# Agenda

## **Ordinary Meeting**

8.1	RESPONDING TO THE CLIMATE EMERGENCY .....	7
8.2	DEVELOPMENT APPLICATION FOR MATERIAL CHANGE OF USE (RESORT COMPLEX, FOOD & DRINK OUTLET, SHOPS, FUNCTION FACILITY AND BAR) AND OPERATIONAL WORKS AT 10 & 16 BRISBANE RD AND 7 & 9 FIRST AVE, MOOLOOLABA....	17

Figure 4 Concept Design with generic coastal themes

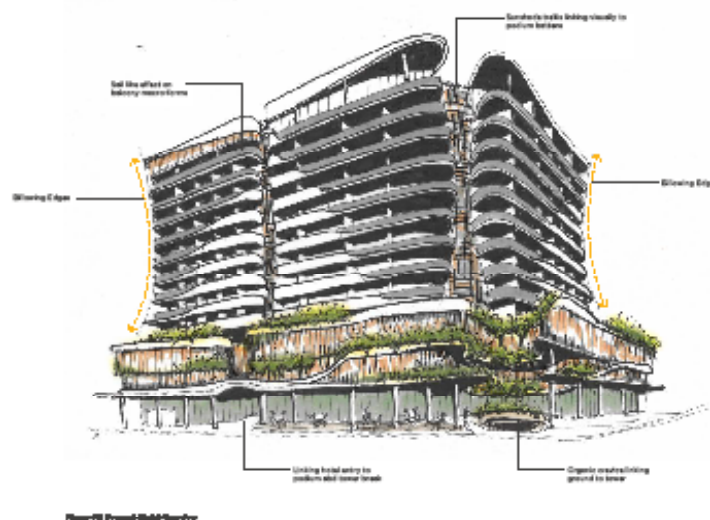
The assessment team Advice was given that the pre-lodgement design concept proposed by the applicants (Figure 3) was generic and not responsive or specific to the site. The applicants sought additional design advice and a new, more sophisticated concept design was presented (Figure 4), although the language in the report has remained the same.

Figure 9 Amendments to First Avenue Streetscape to address Safety and Security

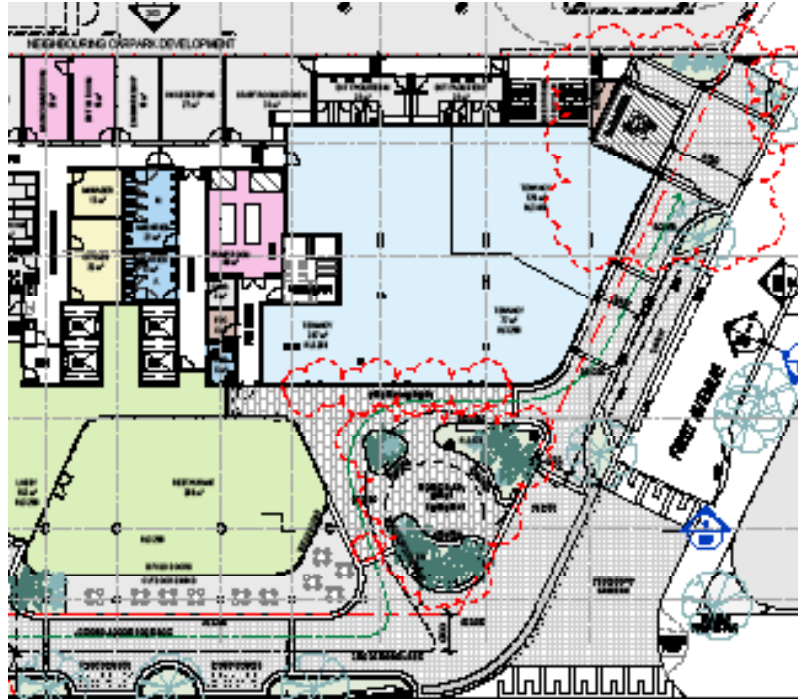
A condition ensuring future wind tunnels tests throughout subsequent assessment phases is recommended to ensure the upper level design of the podium and tower will create optimal conditions for users at ground level.

CD-901: Construction Details 01. Detail 5: **GB3 Typical Podium Planter mix detail** - depth of planting media says 'refer to plans'. Landscape plans provide no information around planting medium depths. CD-402 landscape sections provide no information on the planting media depths.

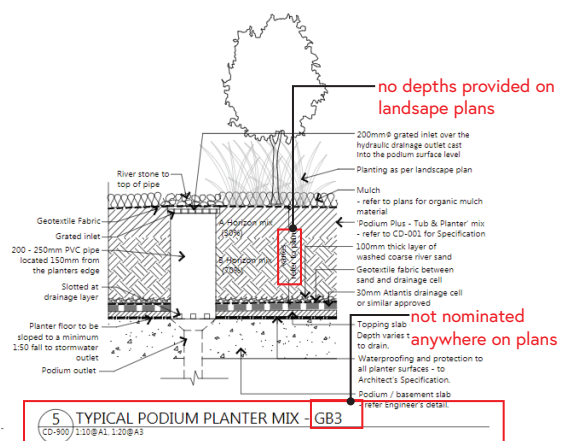
There is insufficient detail provided in the landscape documentation package to assess whether the podium planters provided on podium levels are of sufficient size to provide the soil medium (depth and width) for the proposed planting palette.

Typical Podium planter mix detail appears on CD-900 (dated 2021.04.22) and CD-901 (dated 2021.08.20)

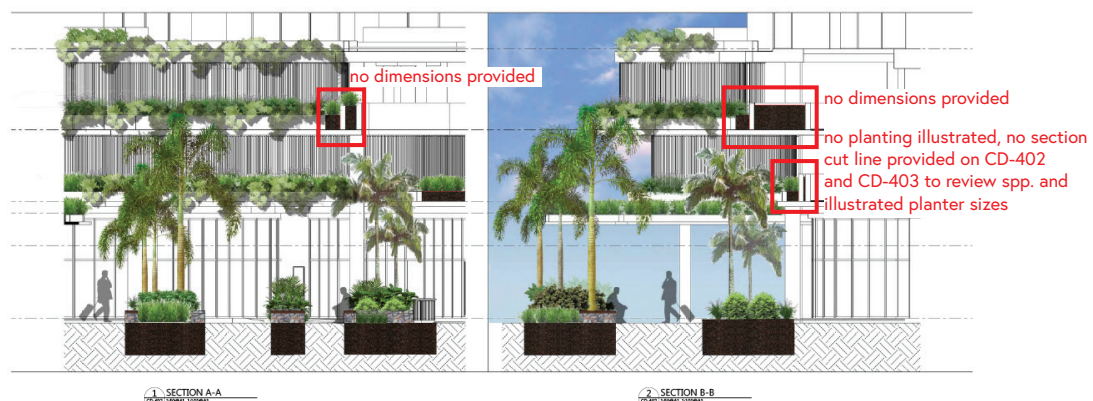
CD-900 is not listed in the drawing register

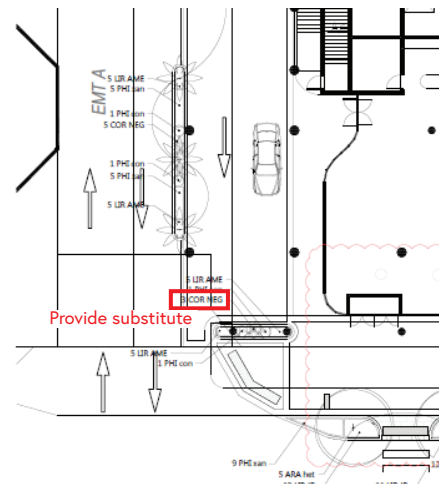
**Port Cochere** - Landscape drawing CD-401, It is recommended that COR neg is substituted for an alternative species growing to a maximum 600mm at maturity (refer image top right) to maintain sightlines.

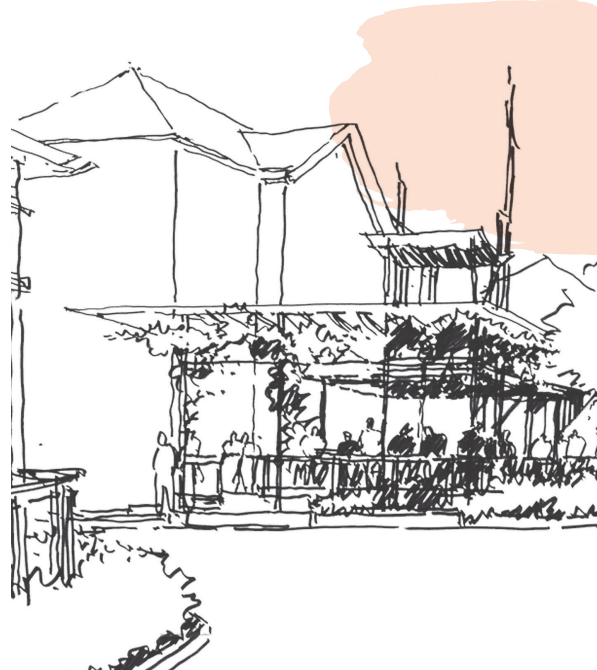
- Notably the PAN tec nominated on level 03 appears to not be located within the 1m deep planter provision. This planter should be 1m deep.

- Insufficient information around the planter widths on the rooftop (level 13) to ascertain whether the nominated trees will survive. *Widths of planters appear to be narrow specifically for the root growth form of the PAN tec.*
